# RISC OS 3 software upgrade fitting instructions: Errata

## Incorrect diagrams

Archimedes 540 and Acorn R260 computers

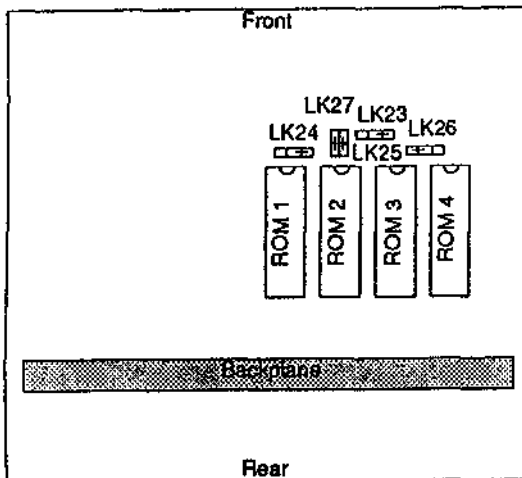
Please note that the diagrams on pages 20 and 32 are incorrect, showing the ROMs the wrong way round, although the text does describe the correct way to fit the ROMs. The correct diagrams are included below.

This is the correct diagram for page 20:
